R66 F049 Engine Electrical Harness Upgrade Kit Instructions*(To comply with R66 Service Letter SL-41; Supersedes KI-268)*

Applicable to helicopter S/N 0274 & prior. Replaces previous F049-02 & F049-09 engine harnesses with F049-012. Isolates engine oil pressure warning light ground thru F059-01 cabin harness [Revision I & prior]. Compliance with Rolls-Royce Service Bulletin RR300-72-014 must be accomplished prior to, or simultaneously.

FIGURE 1 D38999/26FC35SN plug
(F059-01 cabin harness assembly)

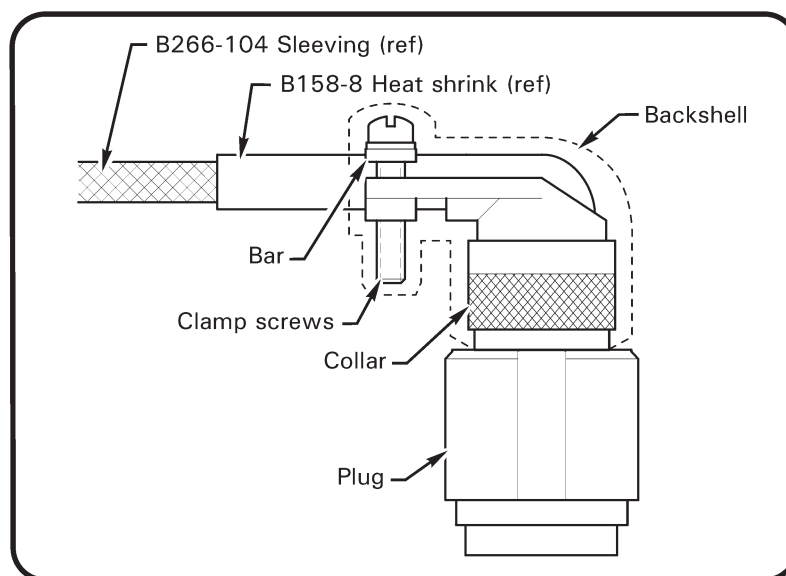
3. Refer to Illustrated Parts Catalog (IPC) Figure 71-3 and Figure 1. Locate D38999/26FC35SN plug on F059-01 (cabin) electrical harness. Remove and retain clamp screws & bar from backshell and loosen (backshell) collar. Disconnect F059 cabin harness plug from F049 engine harness receptacle. Remove ty-raps securing F059 harness wires to wire bundle.

4. Refer to Figure 1. Carefully route socket of KI-223-1948 wire assembly thru B158-8 heat shrink to cabin harness D38999/26FC35SN plug. Install socket in hole 22 of plug. Verify socket security. Tighten collar. Apply B270-20 adhesive to retained clamp screws and install bar to backshell. Torque screws to 40 in-oz.

FIGURE 2 Bus bar ground location
(view looking forward)

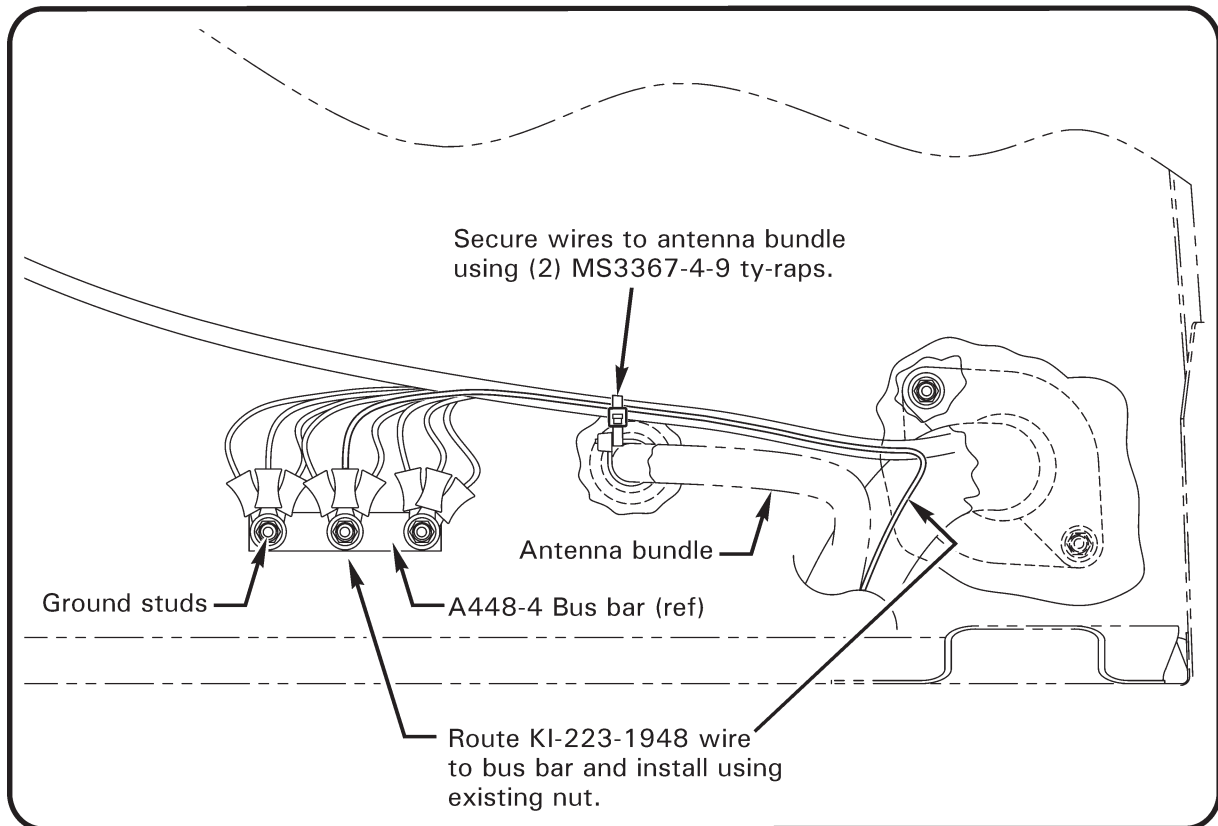
5. Route -1948 wire along F059 harness wires and thru NAS557-14A grommet on firewall, displacing B270-5 sealant as necessary, to ground bus depicted in Figure 2. Strip end of wire and crimp on B260-3 ring terminal. Inspect crimp per MM § 20-94 and verify security of terminal. Install terminal on least-populated ground stud using existing nut. Secure wires to harness using appropriately-sized ty-raps as required. Remove redundant ty-raps as desired.

FIGURE 3

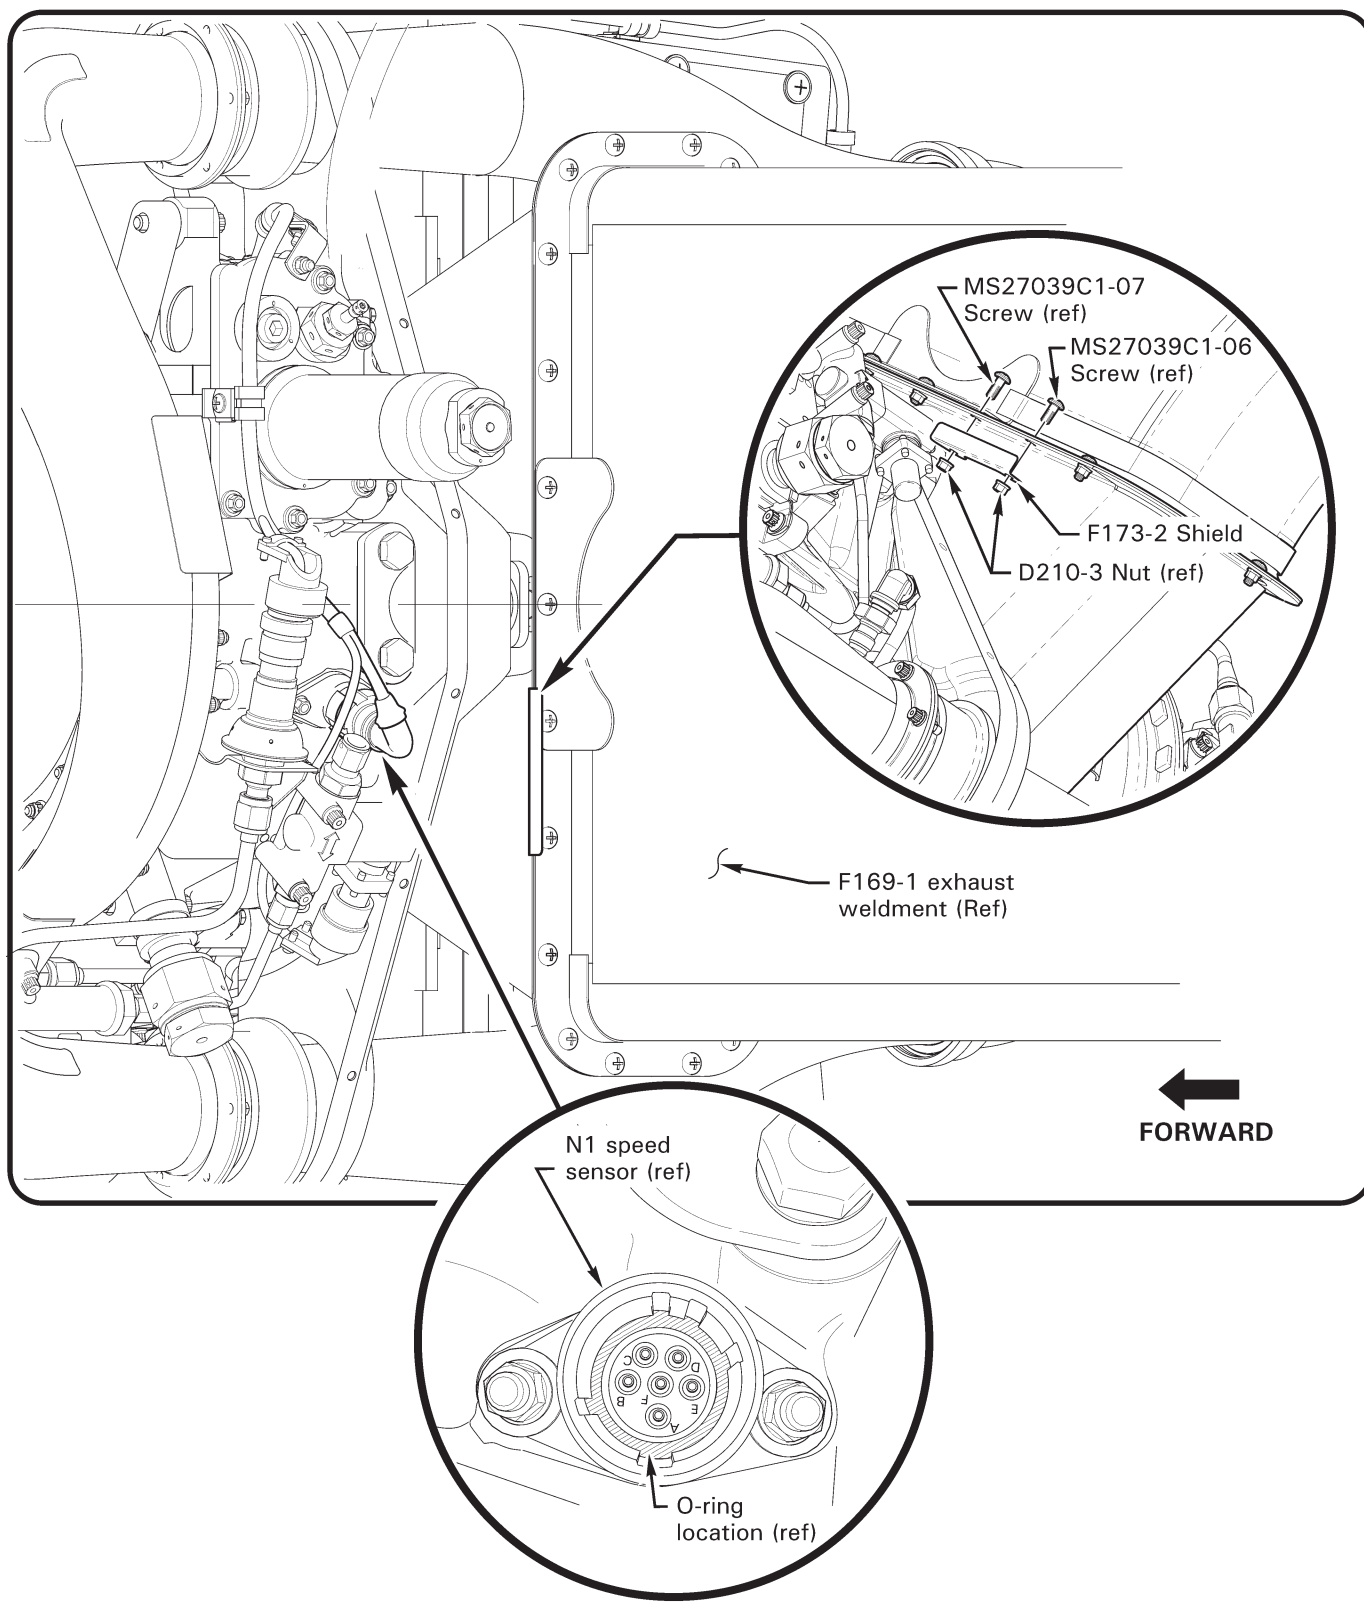
6. Remove F049-02 or -09 harness per MM § 71-11, step 4, retaining installation hardware.
7. Refer to Figure 3. In N1 speed sensor's connector cavity, carefully remove existing O-ring using probe provided. Clean pins with acid brush dipped in isopropyl alcohol. Blow dry using compressed air. Install 1182N111 O-ring; avoid damaging adjacent pins.

10. Refer to Figure 3. Remove & retain one MS27039C1-06 screw & one MS27039C1-07 screw and two nuts at locations shown.
11. Install F173-2 shield as shown, using retained hardware. Standard torque screws per MM § 20-32.
